**Minutes of Pre-Bid Conference**

PROJECT: WBS 42575.3.1 / DO00124 / BK-5124 / Burke County Replacing  
Bridge No. 307

3. Revised bid sheet page 135 is attached adding a bid item for “Right of Way Markers.”
4. Revised plan sheet numbers 2, 3, 4, 5, 6, 7, 9, 10, 12 and 13 are attached, reflecting the changes of cast-in-place concrete barrier rails to precast concrete barrier rails.
5. Environmental permit information is attached.

1 SUBSTRUCTURE ABUTMENT NO. 2

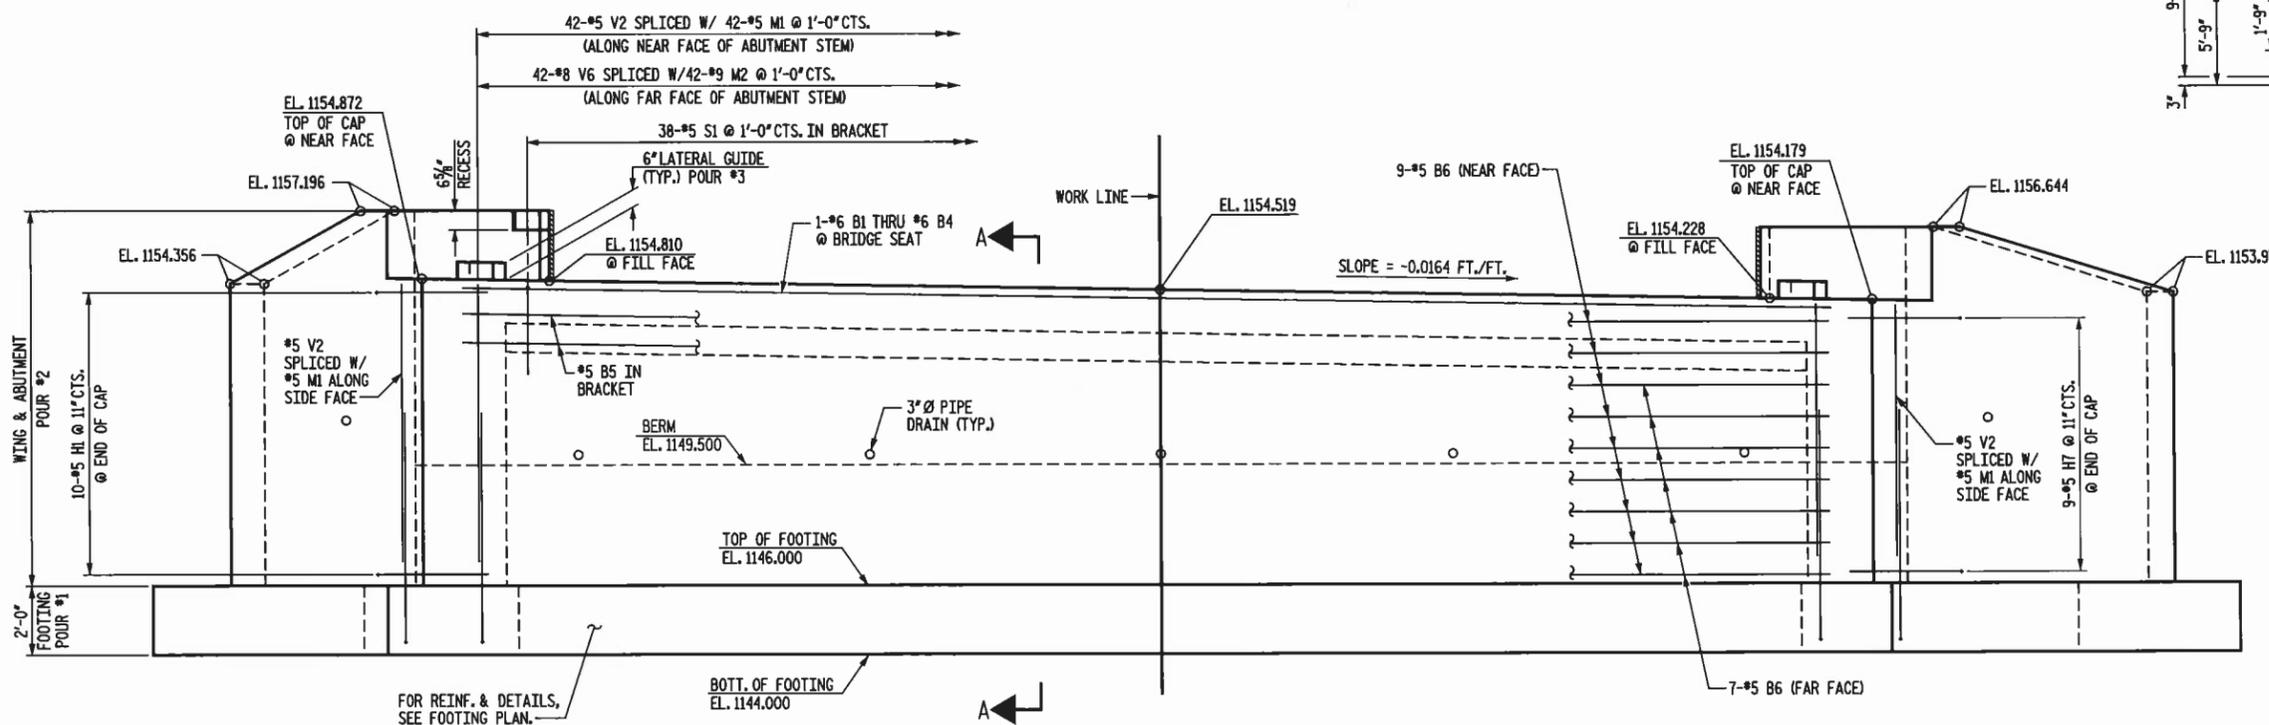
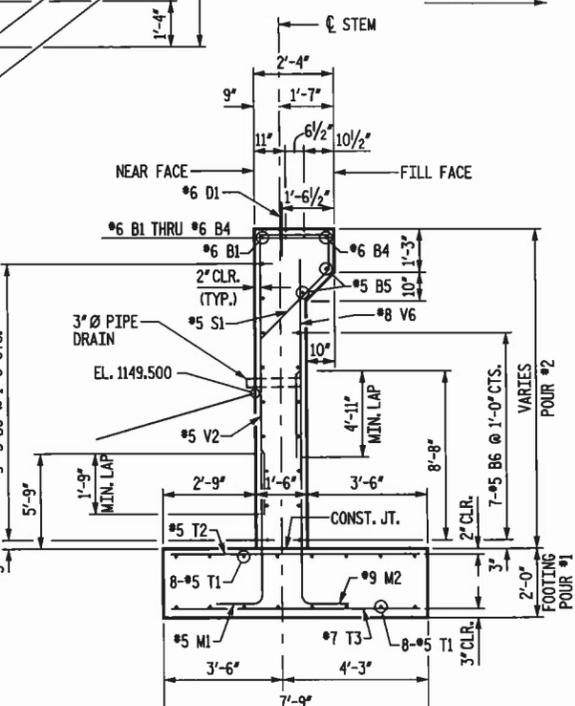
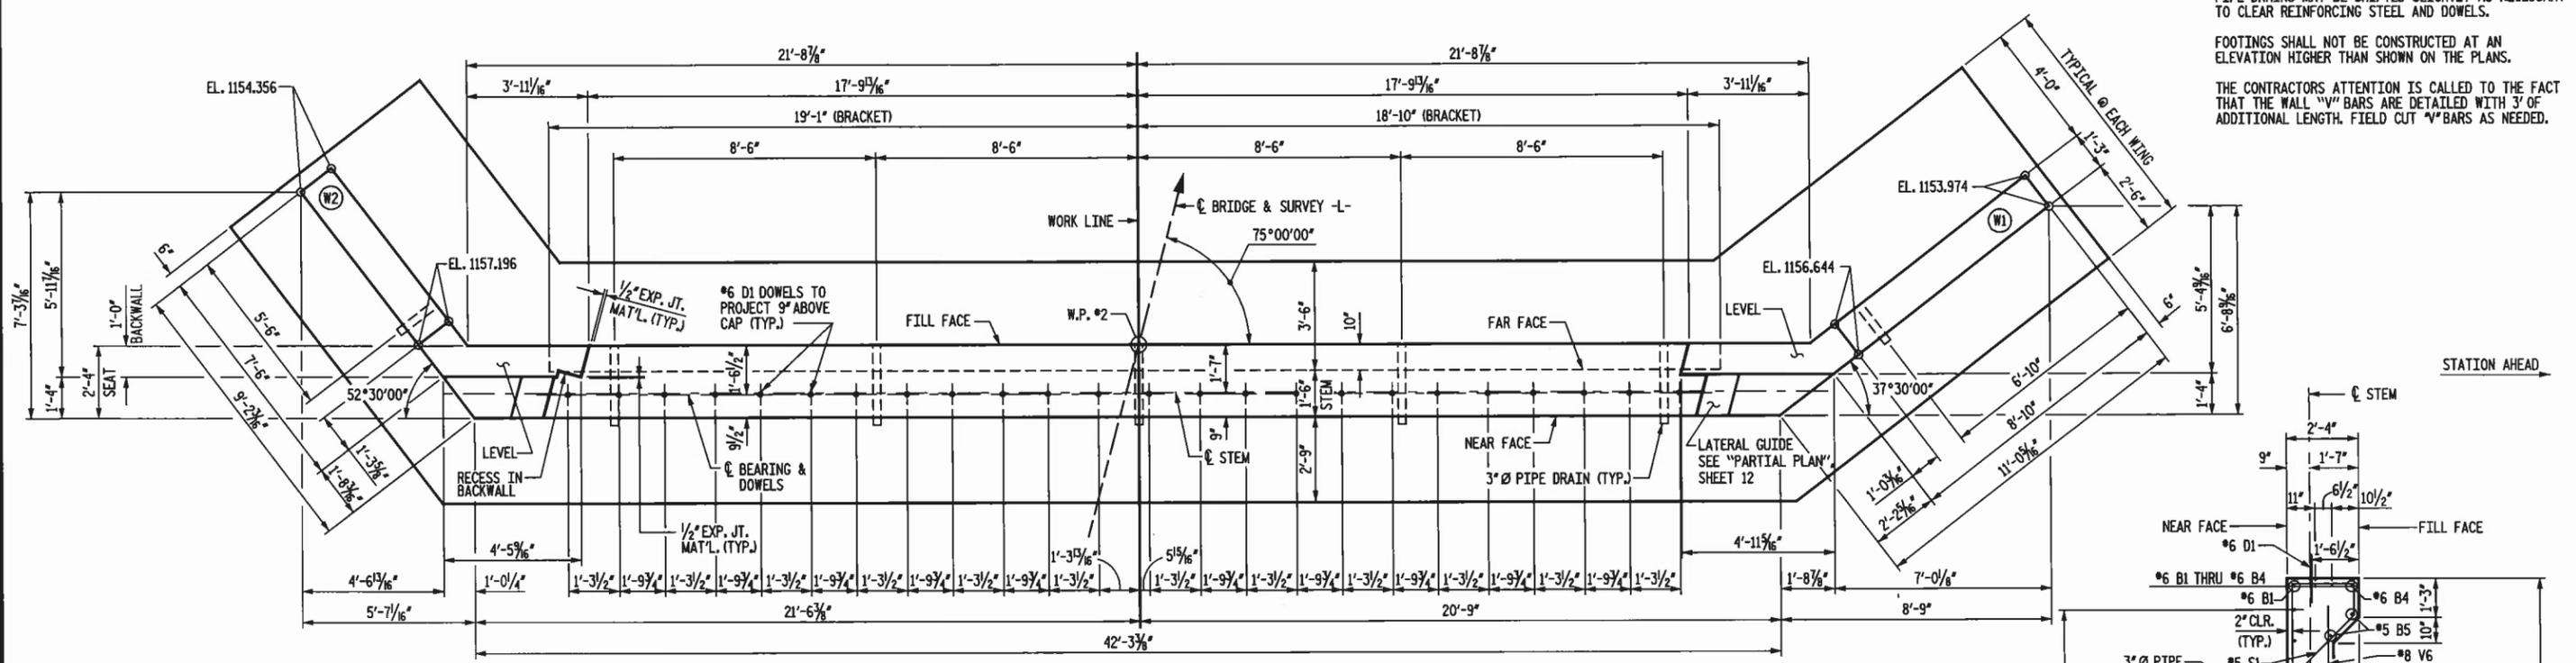
1 REPLACES DRAWING 10 (6-7-11)

1 SUBSTRUCTURE  
ABUTMENT NO. 2  
WING DETAILS

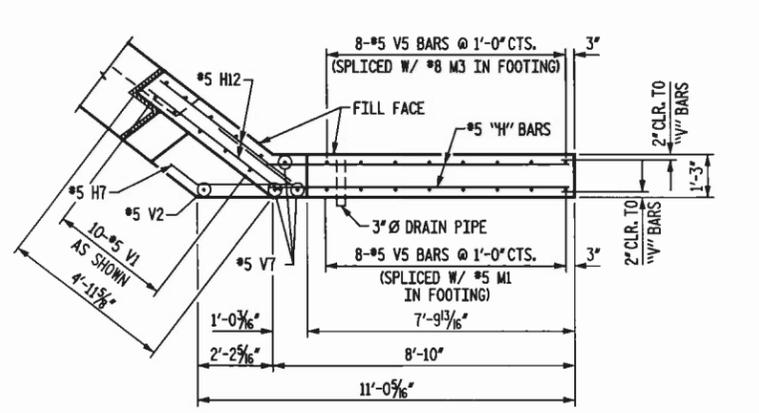
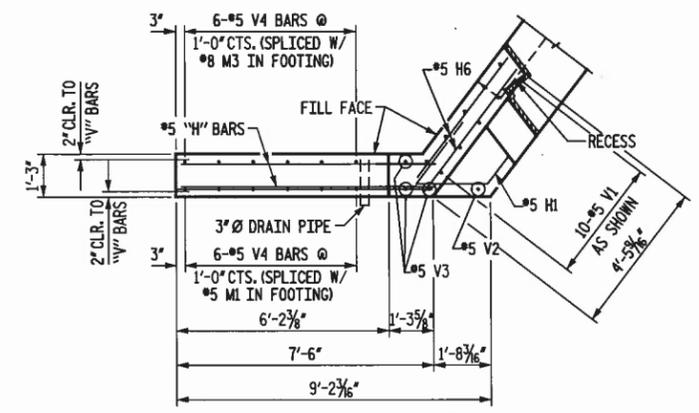
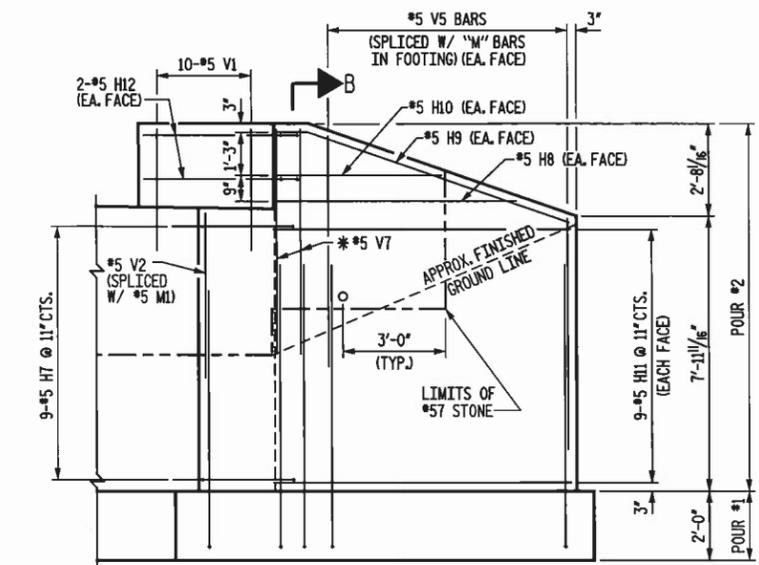
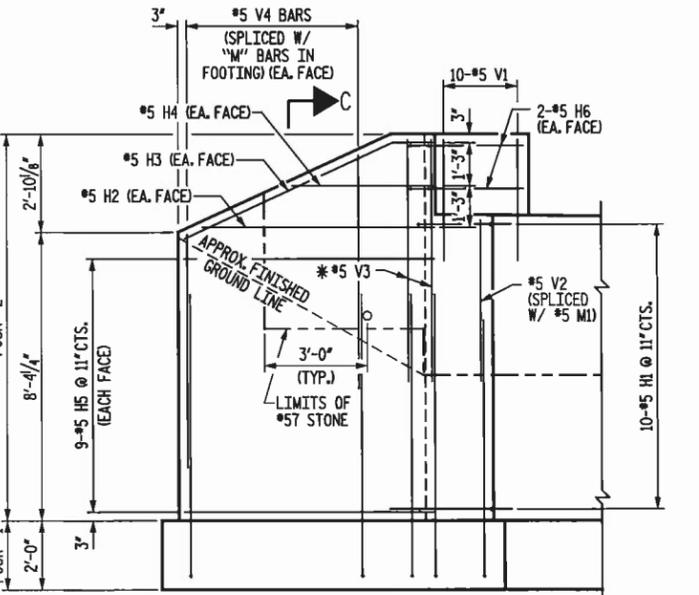
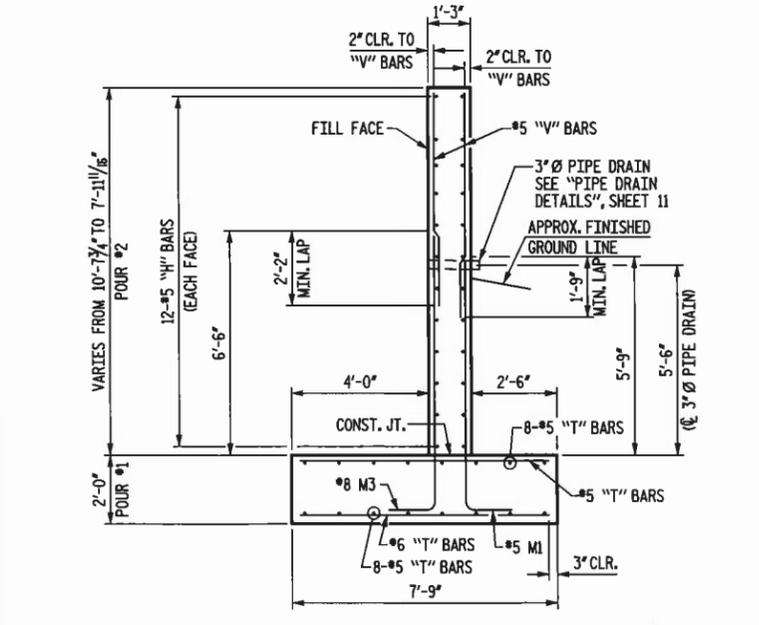
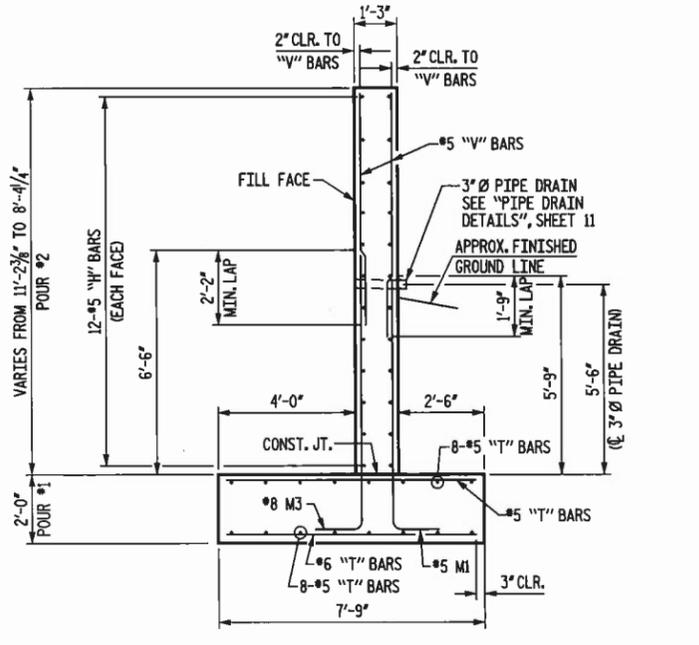
1 REPLACES DRAWING 12 (6-7-11)

STATE OF NORTH CAROLINA  
DEPARTMENT OF TRANSPORTATION  
RALEIGH  
1 APPROACH SLAB  
32'-10" CLEAR ROADWAY  
75° SKEW  
(SUB REGIONAL TIER)

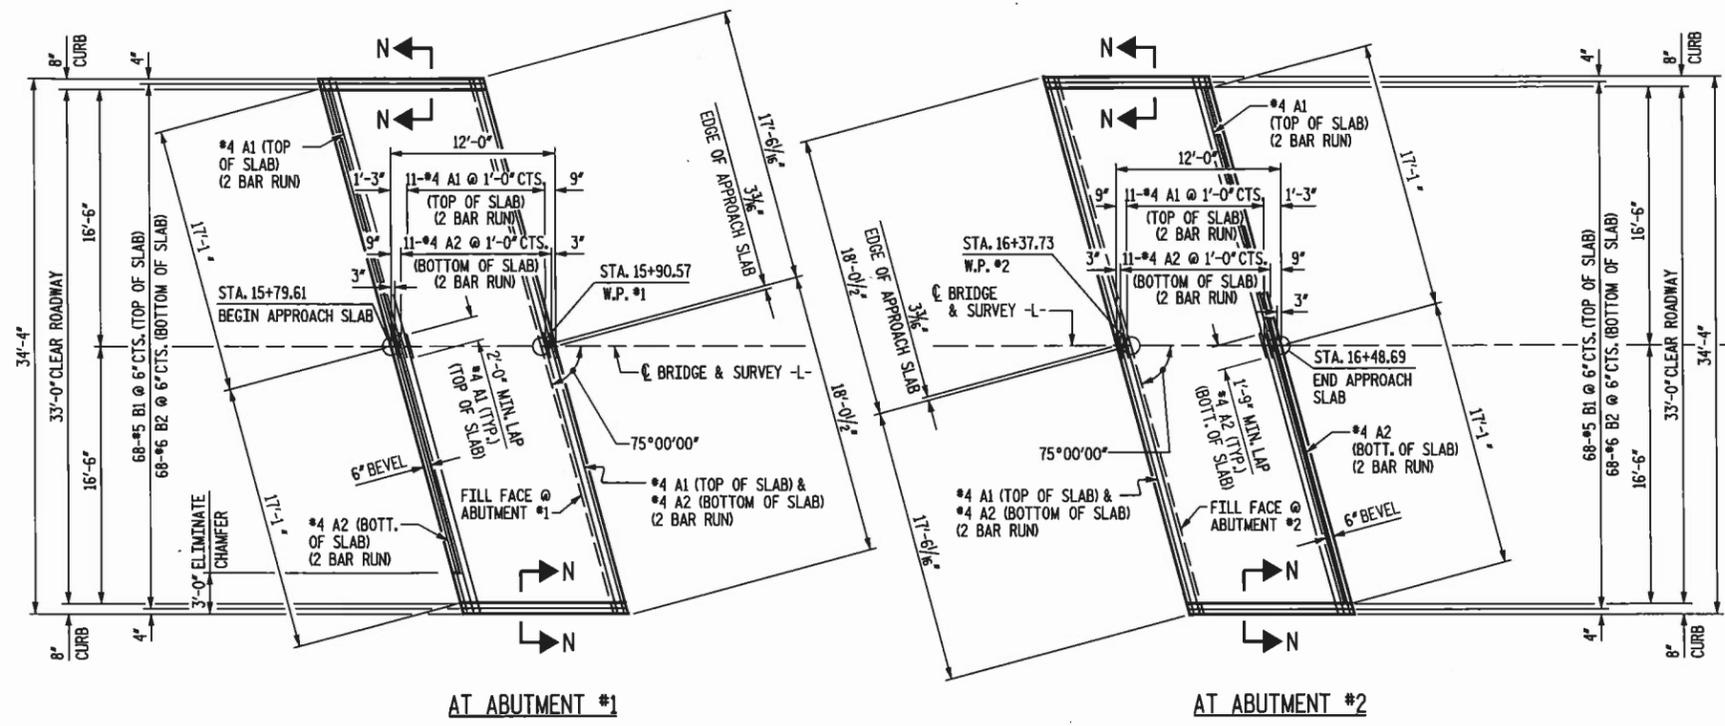
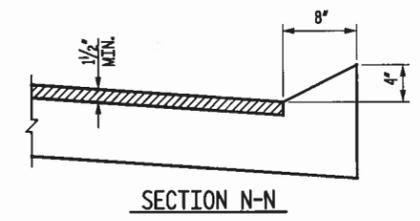
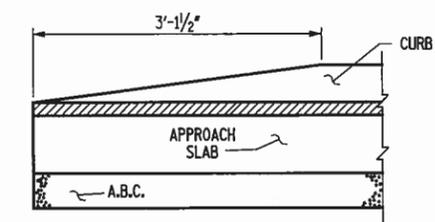
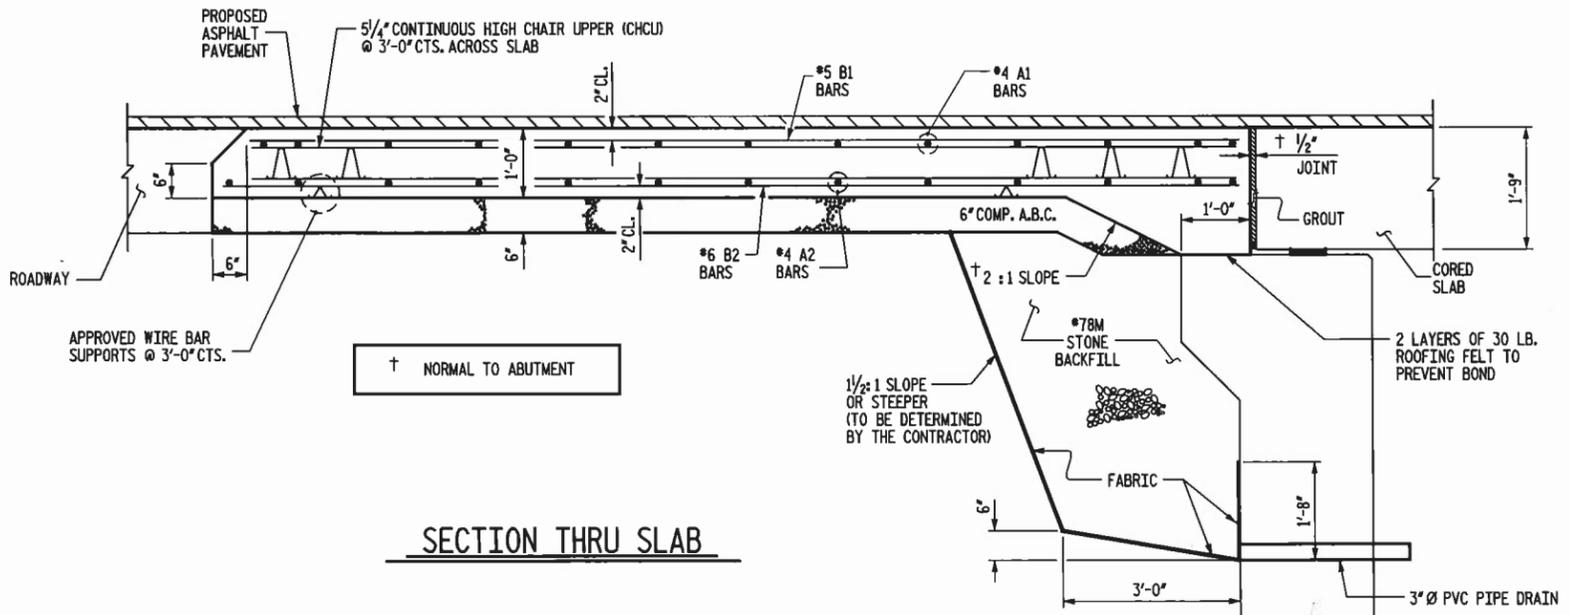
1 REPLACES DRAWING 13 (6-7-11)
